Oyster Creek Generating Station (Oyster Creek)
Facility Operating License No. DPR-16
NRC Docket No. 50-219

Subject: Response To Request For Additional Information – Regarding NRC Generic Letter (GL) 2003-01, “Control Room Habitability,” dated June 12, 2003 (TAC NO. MB9832)

RESPONSE TO REQUEST FOR ADDITIONAL INFORMATION

Lower Cable Spreading Room

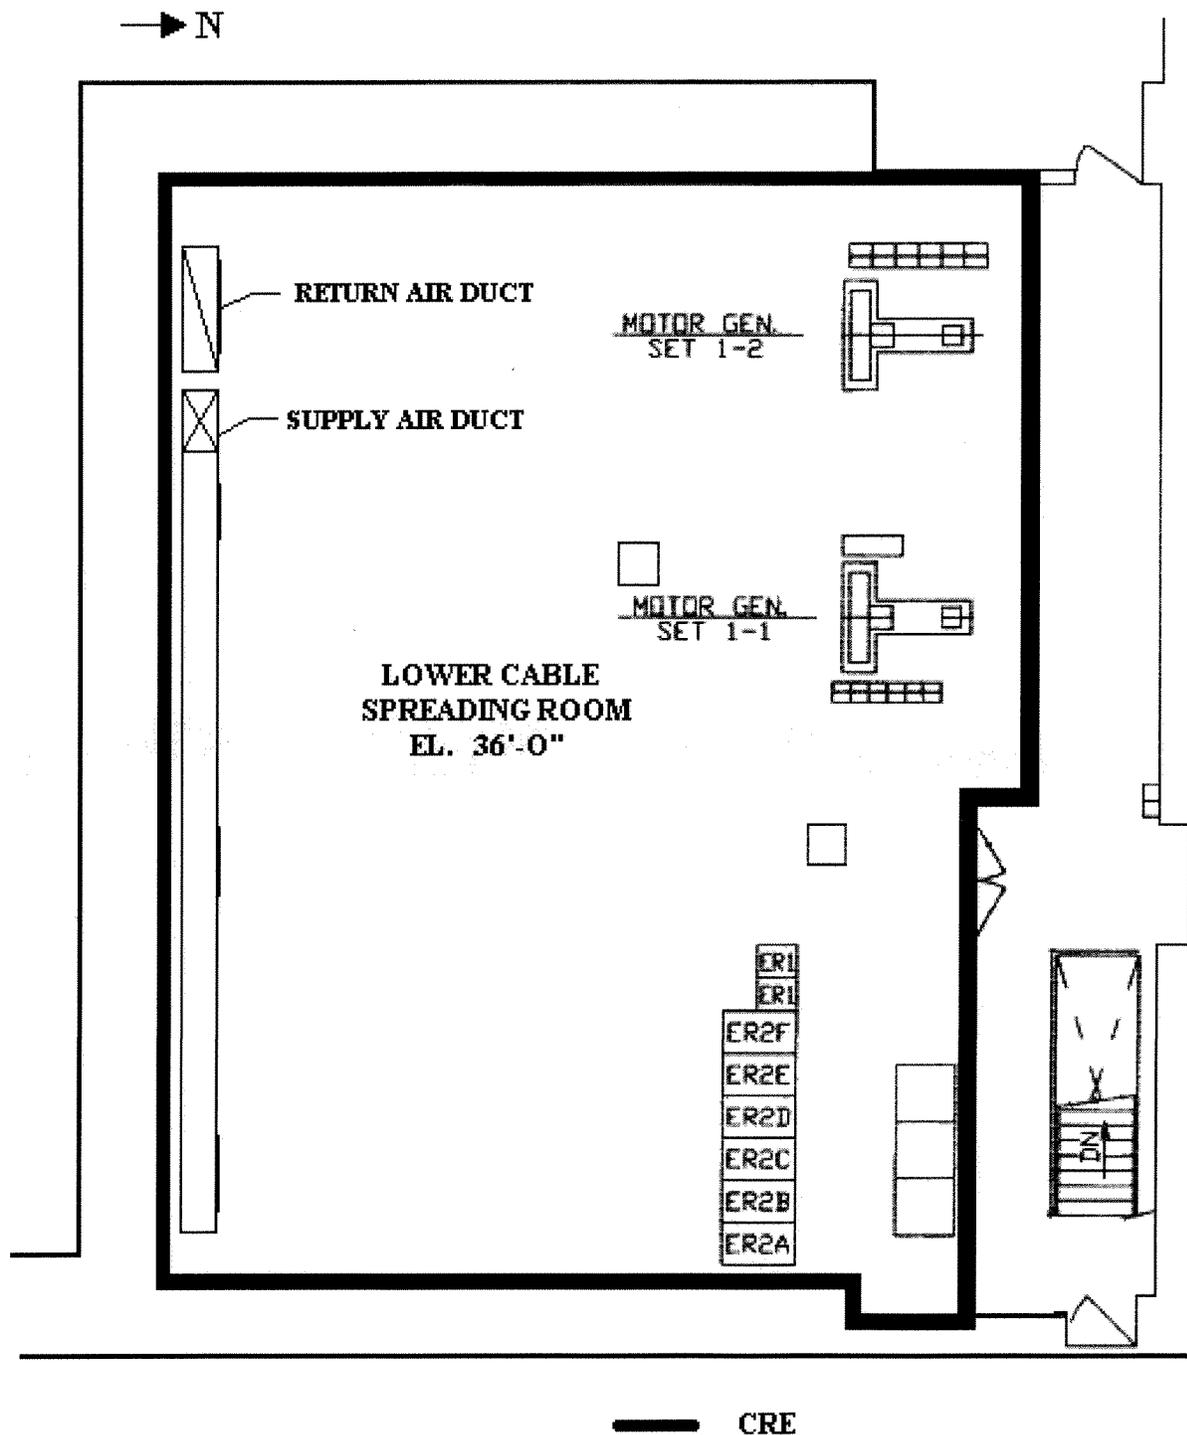
Your response to the GL does not confirm your assumptions for the inleakage characteristics of the control room envelope (CRE). For radiological and hazardous chemical events, in accordance with Items 1a and 1b of the GL, please describe the test and measurements you have performed which demonstrated that the inleakage characteristics of the CRE, including its walls, floors and ceilings, are consistent with the OCNCS licensing basis. Also, please describe how you have determined that the byproducts of a fire or the inadvertent actuation of a fire suppression system will not propagate such that reactor control would be unattainable from either the control room and the alternate shutdown panels.

AmerGen has evaluated potential inleakage from unsealed ductwork and wall penetrations and determined that potential additional inleakage would not be significant, nor would it contribute significantly to control room operator dose. The majority of the control room ventilation system ductwork under negative pressure is in the Upper Cable Spreading Room adjacent to the CRE. A short run of negative pressure ductwork is located in the Lower Cable Spreading Room, which is within the CRE. Attachments 1 through 4 provide layout drawings of the Lower Cable Spreading Room, Main Control

The Control Room and the Lower Cable Spreading Room are serviced by the same ventilation system. Both areas are pressurized in the partial recirculation mode of operation, thereby preventing infiltration from adjacent areas through penetrations and doors. In addition, the walls, floors and ceilings are concrete or concrete block, and all penetrations into adjacent areas have fire rated seals and the conduits through these penetration seals are sealed internally. These penetration seals are included in a surveillance procedure to visually verify their integrity on an annual basis.
